KEWAUNEE NUCLEAR POWER PLANT  
AEC DOCKET 50-305

On November 3, 1972, we received your oral request to provide additional data on the steam lines and other lines carrying fluids at high energy. We understand you are interested in information about our approach to design with regard to the postulated failure of these high energy piping systems (combined pressure and temperature) in the Auxiliary Building. In the short time available to us we have principally concentrated on providing additional information about the design of these systems, their location in the buildings and the consequences of the ruptures considered in design. We are attaching this preliminary informational response entitled "Preliminary Response to AEC-DOL Staff Oral Questions of November 3, 1972."

PRELIMINARY RESPONSE  
TO  
AEC-DOL STAFF ORAL  
QUESTIONS OF NOVEMBER 3, 1972

FIGURE I

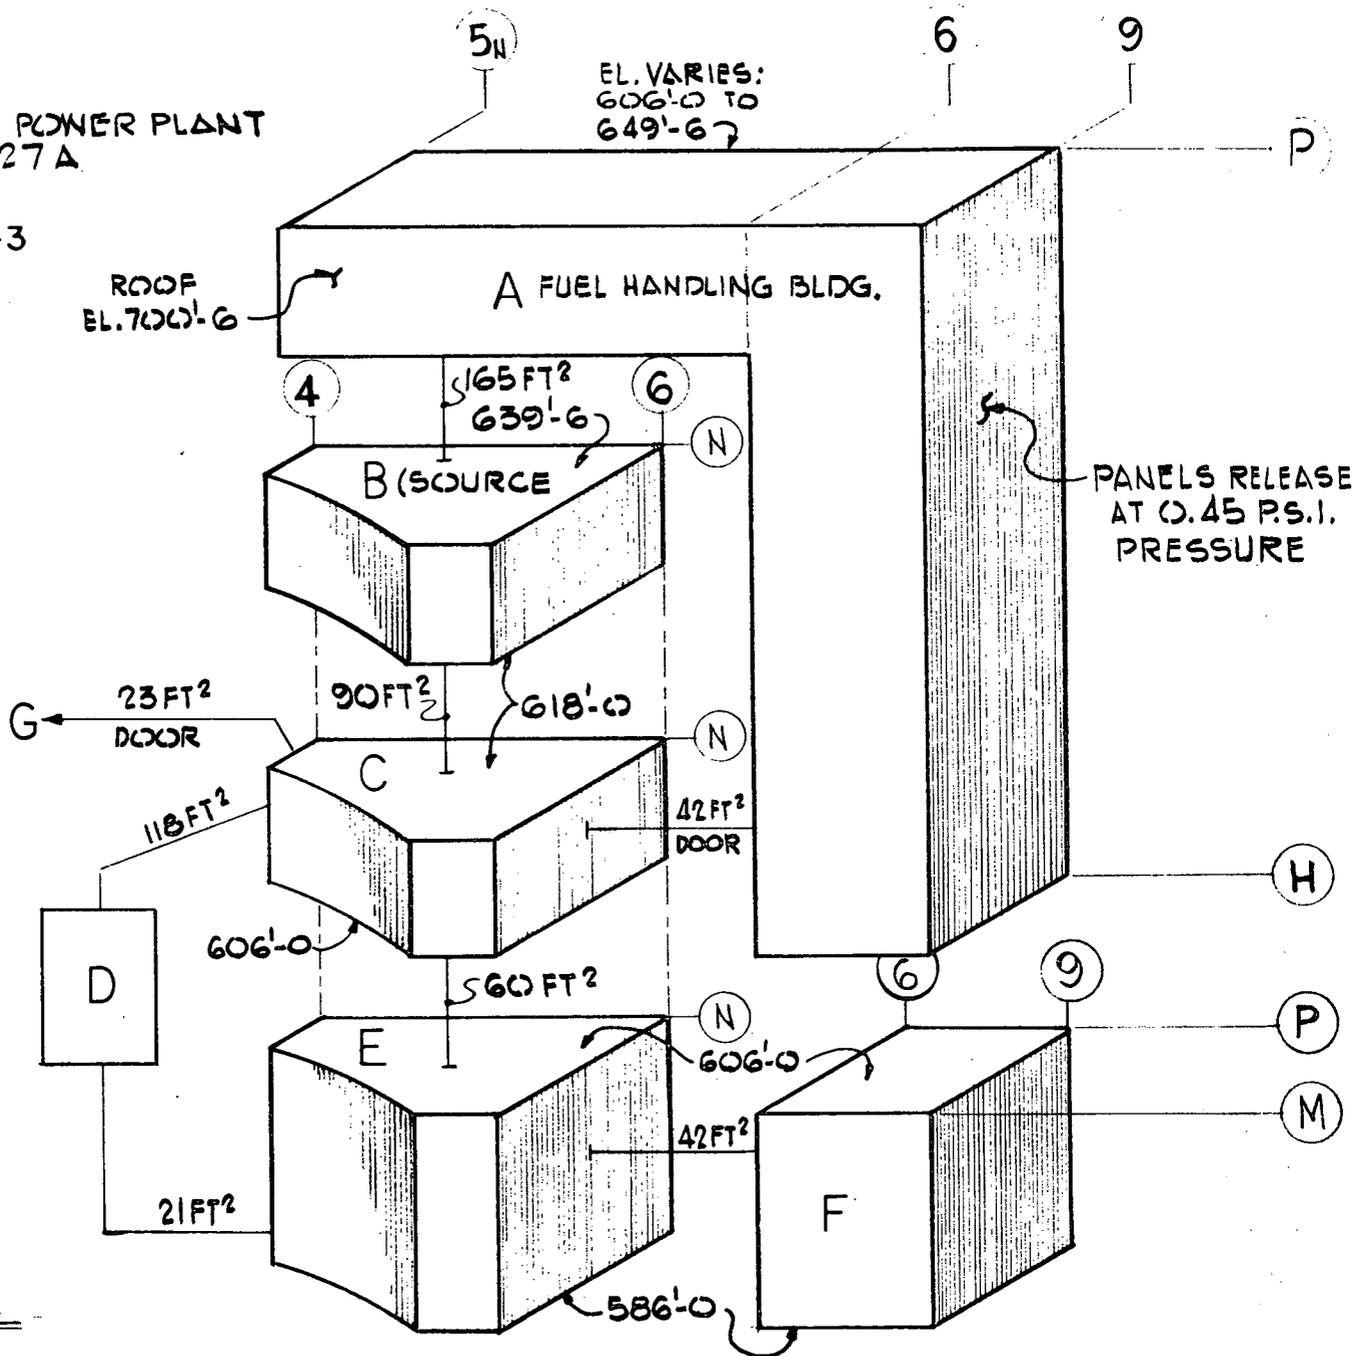
Located at floor elevation 618'-0" in the northwest quadrant on the steam generator 1A side outside of the Containment Building. (See Figure I - Compartment B.)

The volumes and openings between compartments or the atmosphere are shown in Figures I and II.

**FIGURE II**

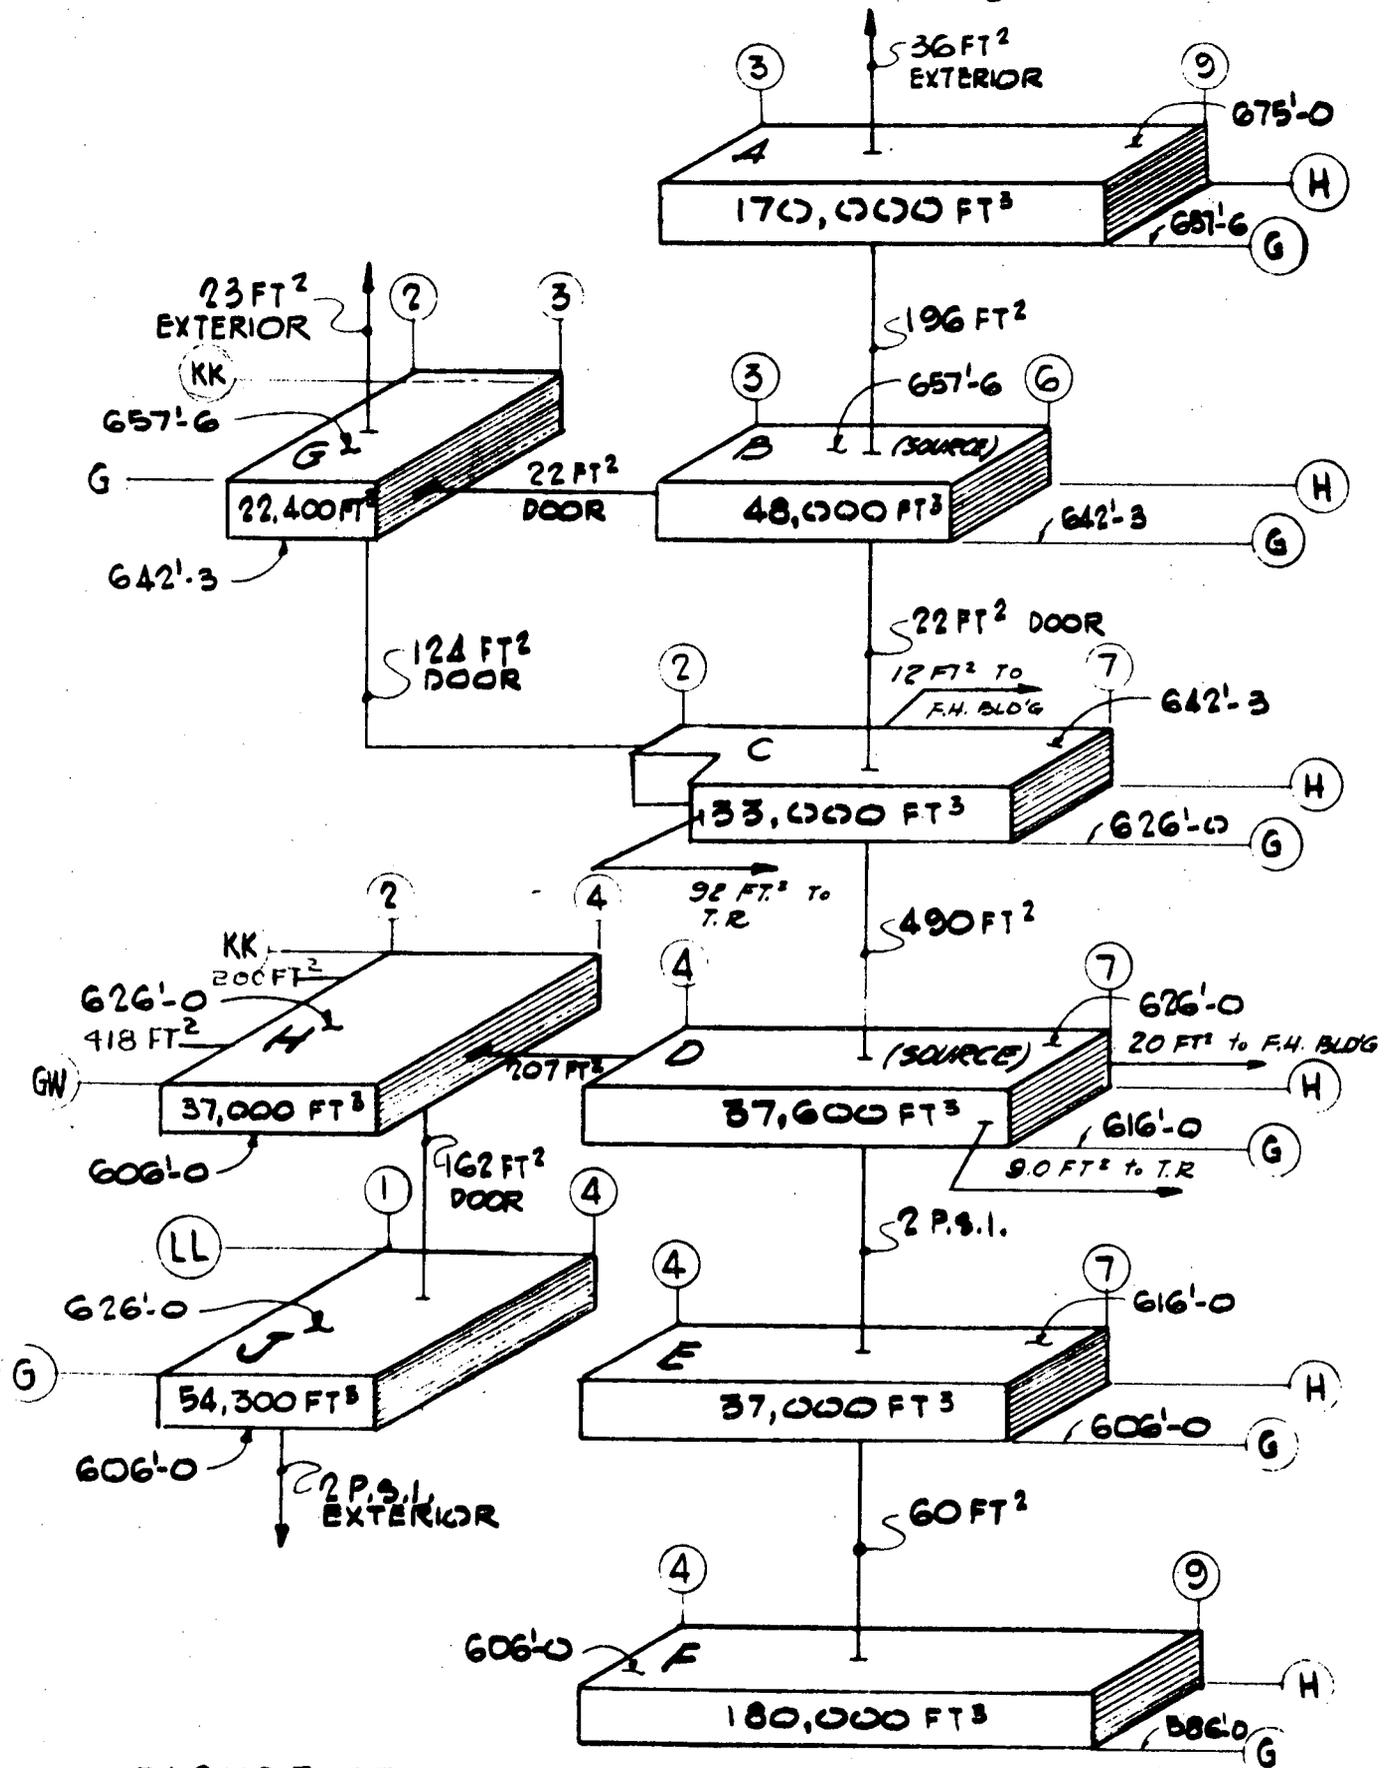
(See Figure II - Compartment D.)

(See Figure II - Compartment B.)
